MODIFICATION REQUEST:
Cardinal Freeman Retirement Village
Concept Plan & Project Approval

MP08_0245 MOD 1

MP08_0260 MOD 1

Director-General's
Environmental Assessment Report
Section 75W of the
Environmental Planning and Assessment Act 1979

Figure 6: Proposed modified Concept Plan layout
(Base image source: proponent's Environmental Assessment)

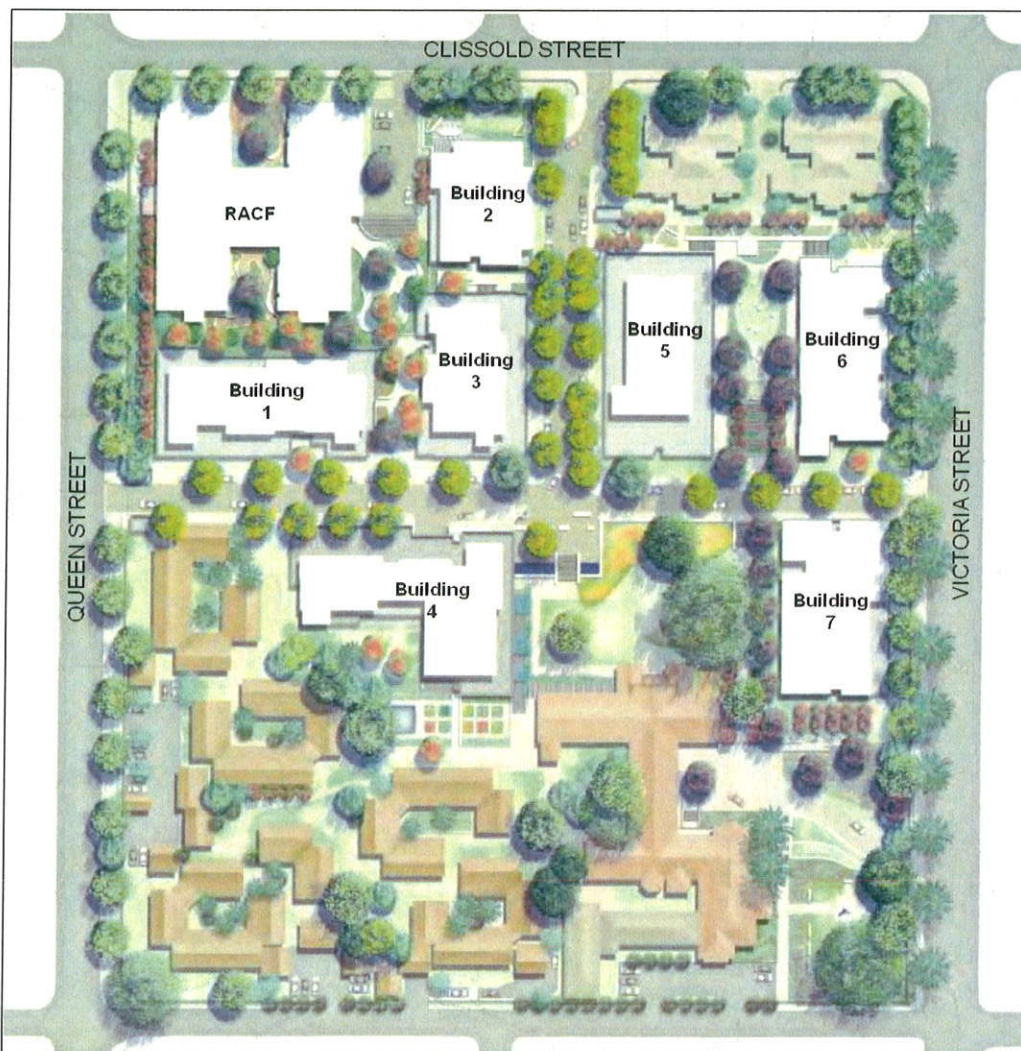
There is an existing east-west road that curves through the site between Victoria Road and Queen Street (**Figure 3**). The approved Concept Plan alters the road layout by straightening the eastern half of the road and realigning the western half, while generally maintaining its curved layout (**Figures 4 and 5**). The proponent is now seeking to realign this through road so that it is completely straight along an east-west axis (**Figure 6**).

A public submission has raised concern that the proposed straightened road will form a 'rat-run', encouraged by the creation of a visual link between Victoria and Queen Streets.

The Department agrees that the proposal improves the setting of the historic items through the improved village green layout and enlarged unobstructed forecourt to Glentworth House. These improvements would allow for a better appreciation of the heritage items by residents and the wider community. The alteration to vehicle and pedestrian legibility of the site is also beneficial.

The Department notes that an east-west road has existed on this site since the commencement of its use as a retirement village in the mid 1970's. The proposal is not creating a new link road, instead just realigning and existing one. The Department acknowledges that the straightened road may create a visual link between Victoria and Queen Streets. However, given that the east-west road meets the middle of both Victoria and Queen Streets, does not connect to a defined destination, or allow a by-pass of an existing busy road it is not considered that the straightening of this existing road would result in a 'rat-run'. Furthermore, the proposed realignment reinforces the grid-like street pattern character of the local area and will allow an improved integration of the Village into the local area. The Department considers that the realignment of the road would not have a material impact on pedestrian or driver safety. It is noted that council and Roads and Maritime Services do not object to the realignment of the central east-west road.

Figure 7: Comparison between approved building heights (left) and modified building heights (right)
(Base image source: proponent's Environmental Assessment)

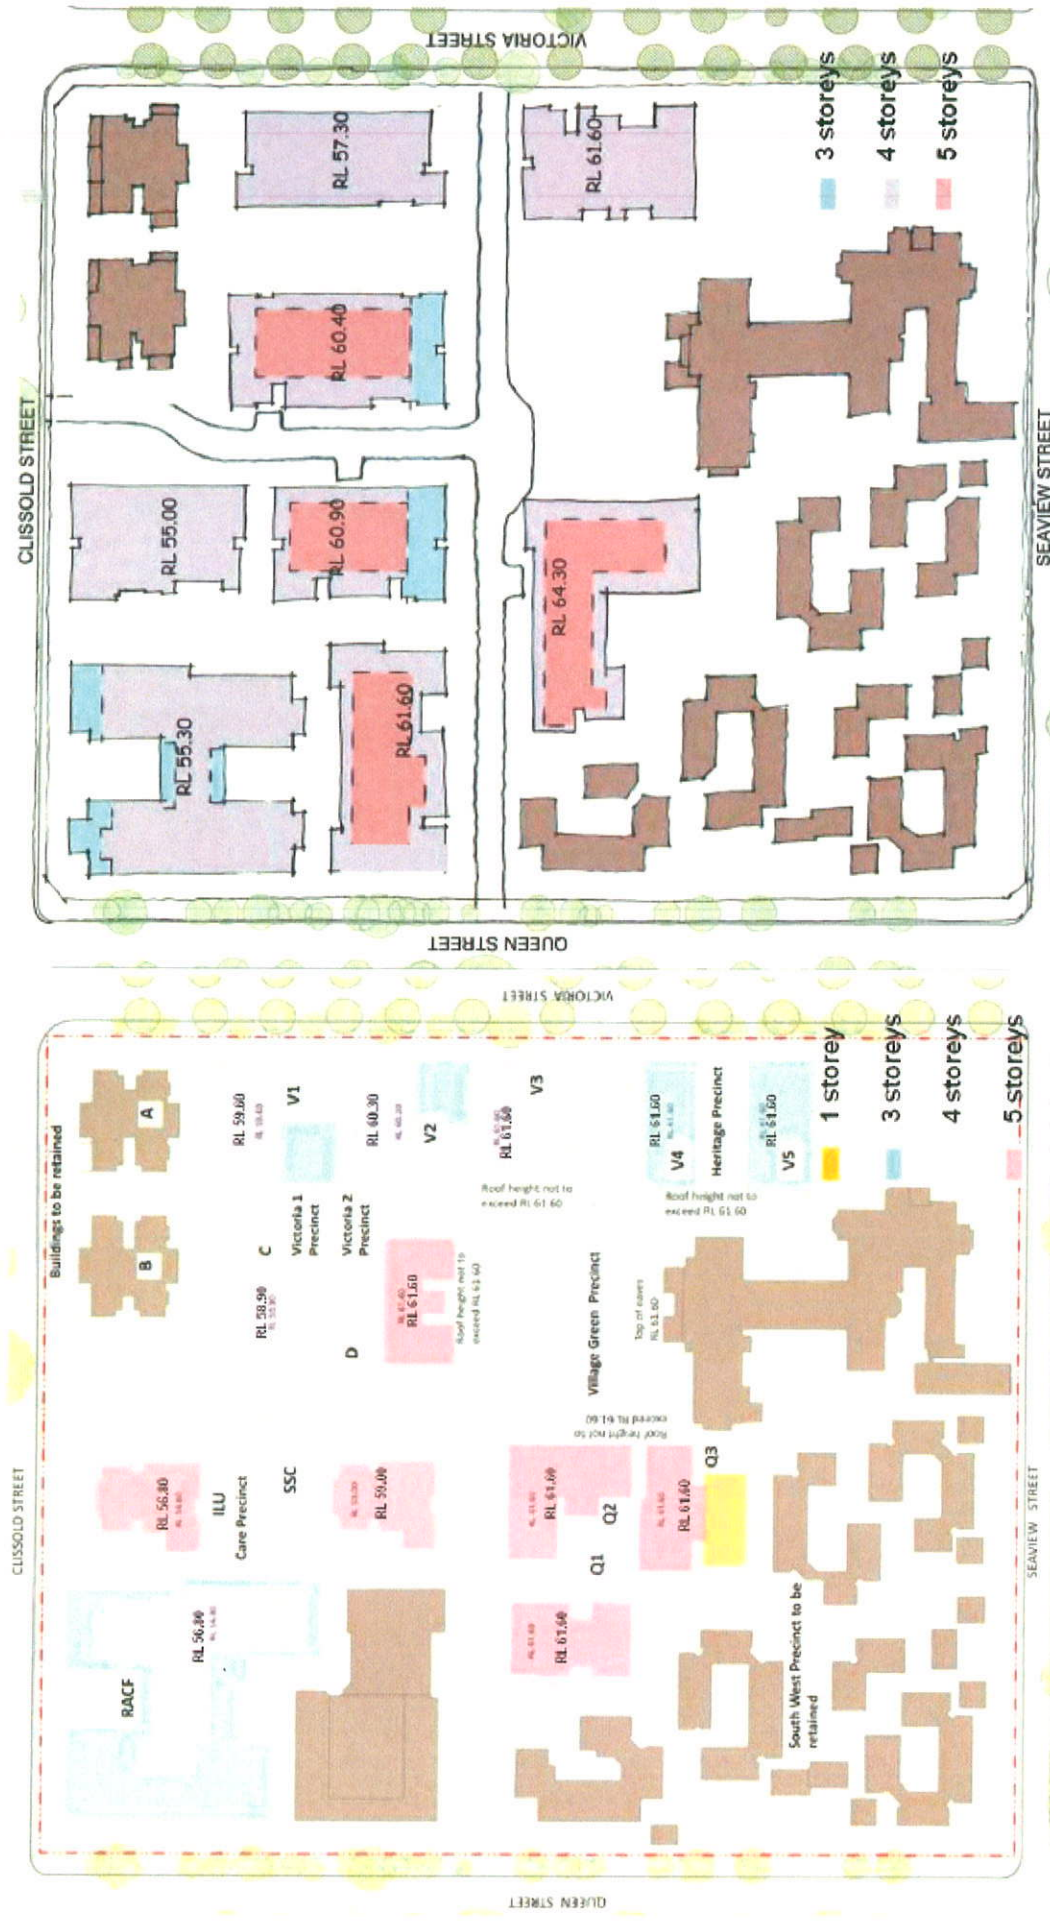
Residents have objected to the inclusion of 5 storey building heights generally and the impact on Queen Street. The approval restricted overall building heights to being no taller than RL 61.60 (excluding rooftop plant/structure) so that no part of the development would rise above the eaves line of the two heritage items on the site. A comparison of the approved and modified building heights is provided at **Figure 7**. There are four buildings with a proposed building height of 5 storeys:

Of the four 5 storey buildings proposed, only one building, Building 4 (equating to an RL of 64.30), would rise above the eaves line of the heritage items (RL 61.60).

The resident suggests that proposed Building 5 would block her view of the heritage precinct. The Department notes that the approval shows Buildings C and D (part 4/5-storeys, **Figure 7**) already largely obscures the heritage precinct from Building B. Proposed Building 5 consolidates buildings C and D into one building envelope and the new B5 envelope is of a similar width as buildings C and D. The Department considers that due to the locations, height and width of Building 5, the modification would not result in further obstruction of the heritage precinct from the objector's property at retained building B.

Buildings B3 and B5 are derived from the consolidation of buildings which, as approved, would have also been 5-storeys (refer to **Figure 7**). The Department notes that although the building envelopes have changed, that the modifications are minor in nature and would not have a significant impact on residential amenity.

Figure 8: Comparison between approved staging plan (left) and modified staging plan (right) (Source: proponent's Environmental Assessment and original approval)

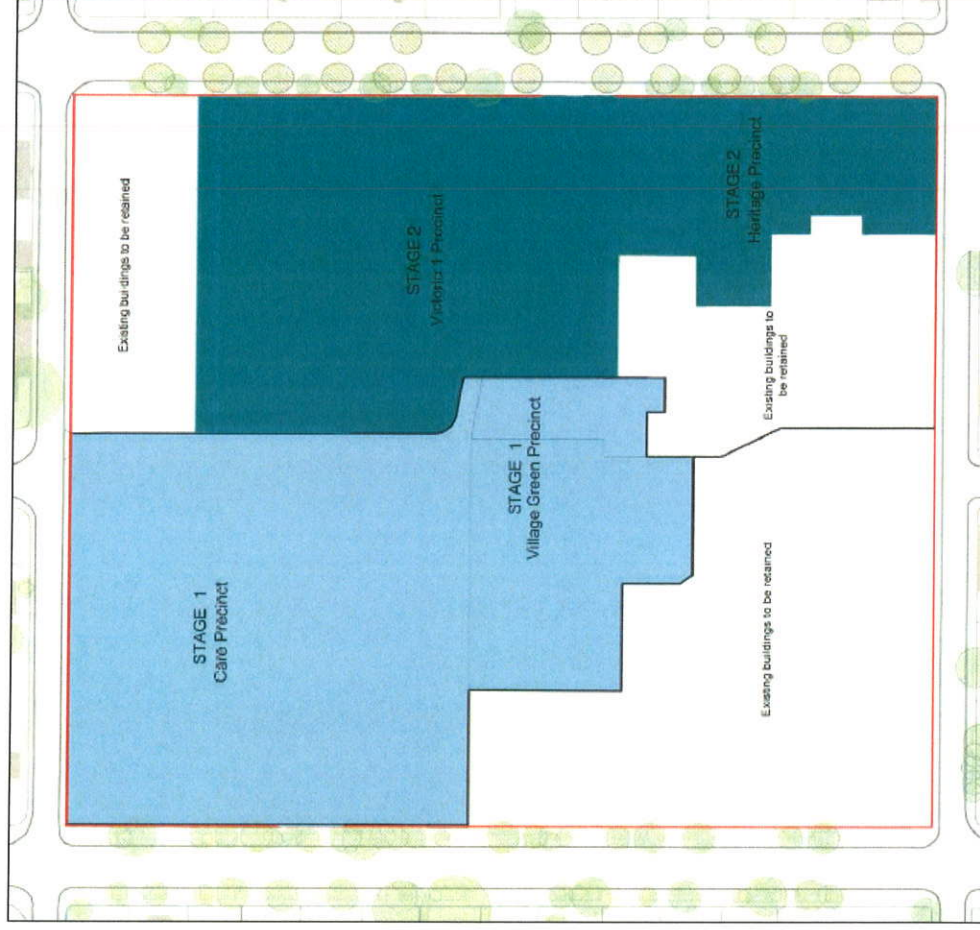
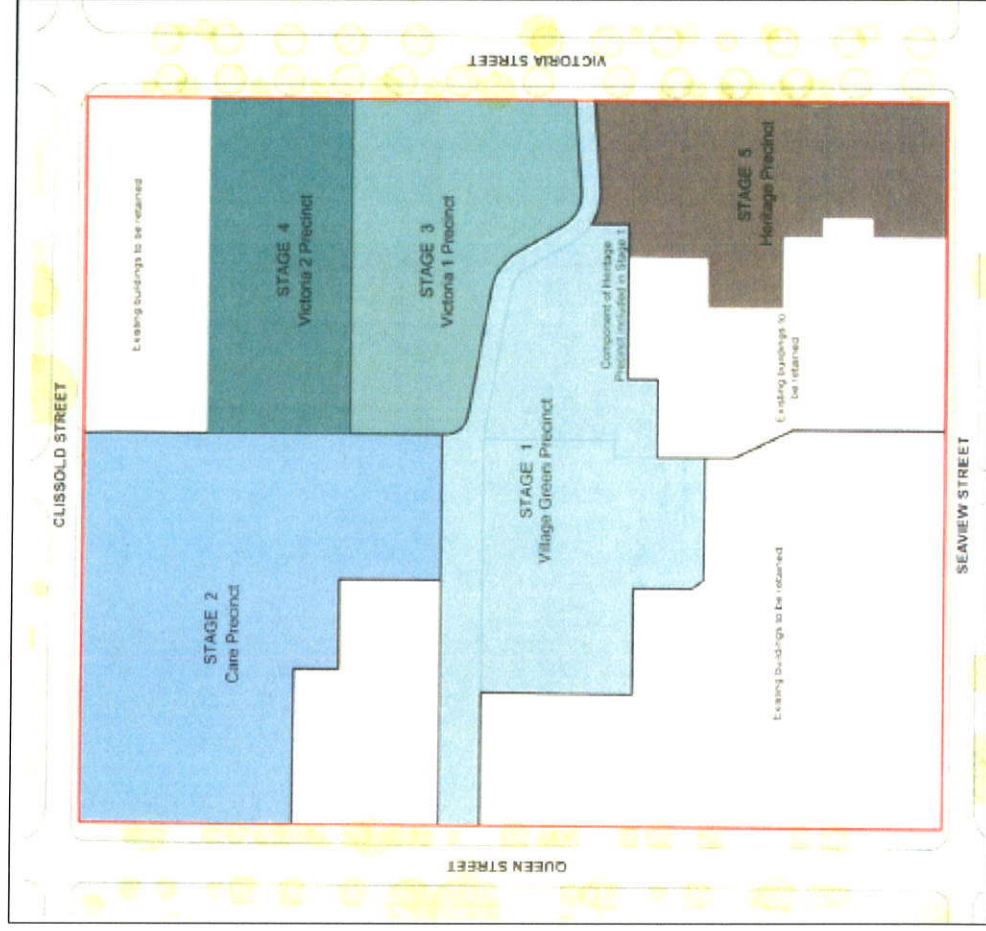
The proposal seeks to reduce the number of construction stages from five to two (Refer **Figure 8**), which will reduce the overall construction timeframe from approximately five to three years. The proponent has stated that this change is in response to residents' wishes for a swift delivery of the development with minimal impact on existing residents and services.

The Department supports the proposed reduced construction timeframe and consolidation of 5 development stages into 2. Further the construction of the Residential Aged Care Facility as part of the first phase of Stage 1 is also supported by existing Village residents. It is recommended that the conditions imposed on the Concept Plan be amended to reflect the revised staging arrangements.

Figure 9: Proposed modified Project Application layout
(Base image source: proponent's Environmental Assessment)

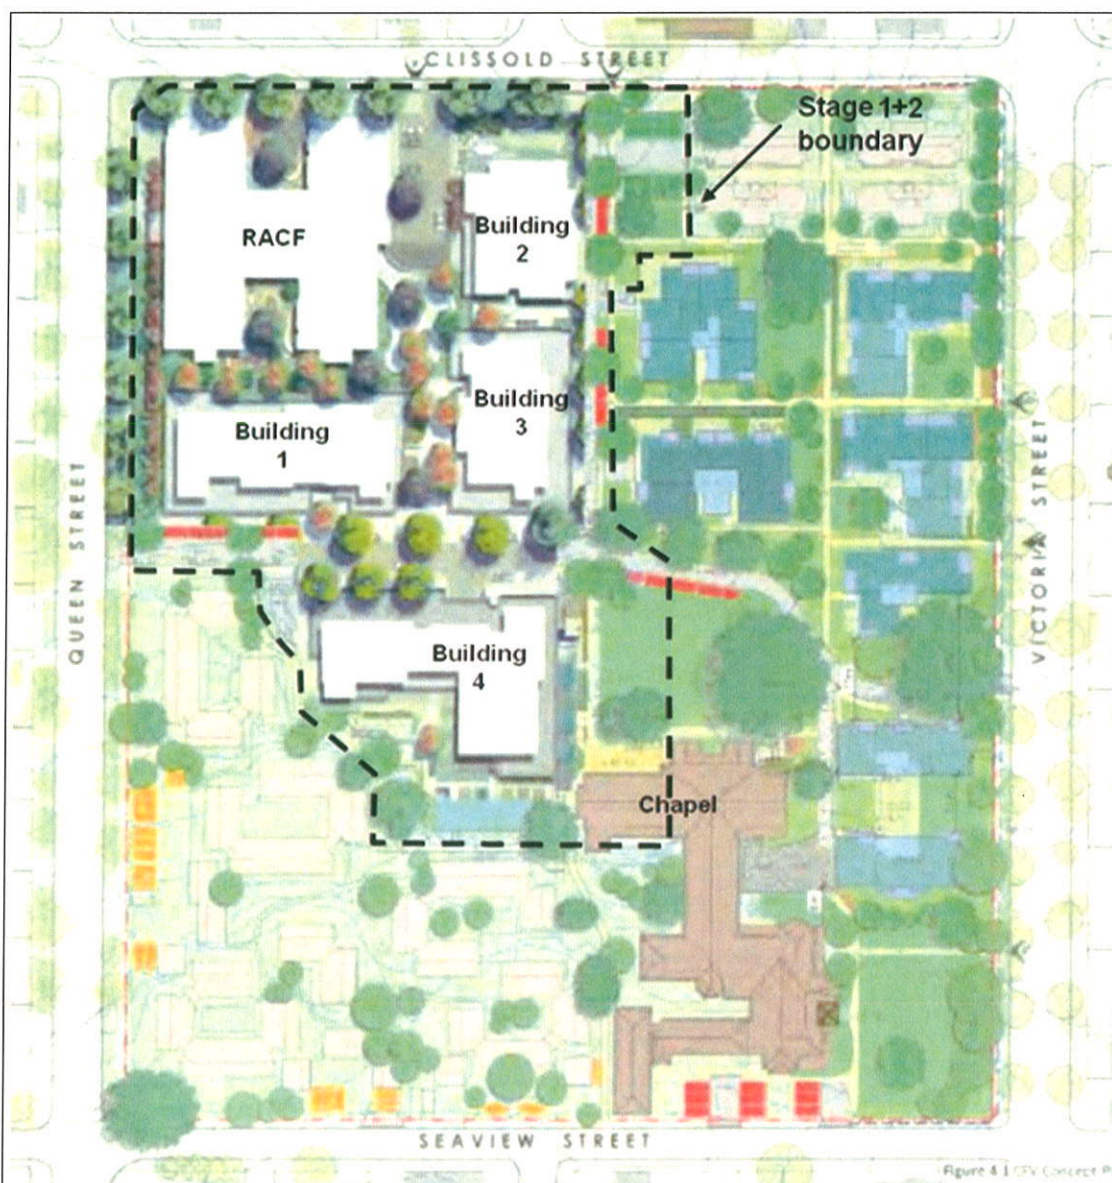
The proposed amendments to the Project Approval (MP 08_0260) issued for the first two stages include:

- Modifications to the internal layout and external treatment of the Residential Aged Care Facility with a relocated porte-cochere and entry;
- Modified internal layout and external treatment of Buildings 2 and 3;

- Consolidation of Buildings Q1, Q2 and Q3 (3 x 5 storeys) into a single 5 storey building (Building 4);
- Change of use of the chapel undercroft from residential units to community facility use;

- An increase of one additional Residential Aged Care Facility bed space (from 132 to 133);
- An increase in the number of Independent Living Units within Stage 1 by 37 (from 104 to 141);

- Demolition of the existing serviced apartment building (49 serviced apartments) and construction of a new Independent Living Unit building (Building 1); and

- Combination of approved stages 1 and 2 into one stage (Stage 1). Reorganisation of construction schedule, with the Residential Aged Care Facility building being commenced first.
